Work Order ID 164203

Item Name: Crosstube Turning Detail

DART AEROSPACE LTD		Work Order:	164203
Description: Crosstube Assembly		Part Number:	D407-667-145
Inspection Dwg: D407-667-145 Rev: C		Page 1 of 2

DRAWING NO. D407-667-145	TITLE CROSSTUBE ASS'Y (407 HIGH FWD)	REV. C	DART AEROSPACE LTD ENGINEERING ORDER		D.E.O. NO. D407-667-145-C-1	SHEET NO. SHEET 1 OF 1	SCALE NTS
DRAWN <i>q</i>	CHECKED <i>ASS</i>	MFG. APPR. <i>is</i>	APPROVED <i>WD</i>		DE APPR. <i>#</i>		
DATE 11.07.15	DATE 11.07.22	DATE 11.07.22	DATE 11/07/22		DATE 11.07.21

DETAIL P
BONDING STRAP INSTALLATION 2 PL

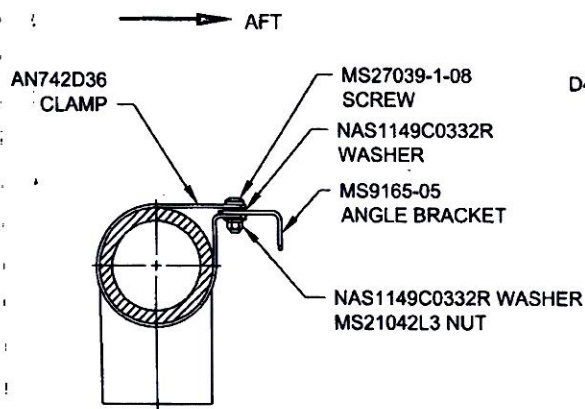
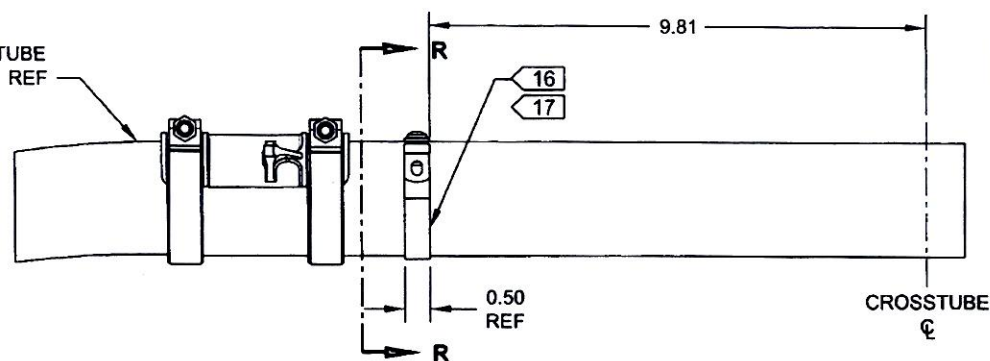
PURPOSE:

ADD ELECTRICAL GROUNDING STRAP

ITEM	QTY -145	PART NUMBER	DESCRIPTION
1	X	D407-667-145	CROSSTUBE ASSEMBLY (407 HIGH FWD)
10	2	AN742D36	CLAMP
11	2	MS9165-05	ANGLE BRACKET
12	2	MS21042L3	NUT (OR MS21042-3)
13	2	MS27039-1-08	SCREW
14	4	NAS1149C0332R	WASHER (OR AN960C10L)

- 16) MASK AREA UNDER CLAMP PRIOR TO PAINTING
- 17) SEAL EDGES WHERE AN742D36 CLAMP MEETS WITH THE CROSSTUBE USING SIKAFLEX-241/-291 OR MIL-S-8802 CLASS B2 OR PROSEAL 890 SEALANT
- 18) PERFORM RESISTANCE CHECK TO ENSURE MAX RESISTANCE IS 10 MILLIOHMS
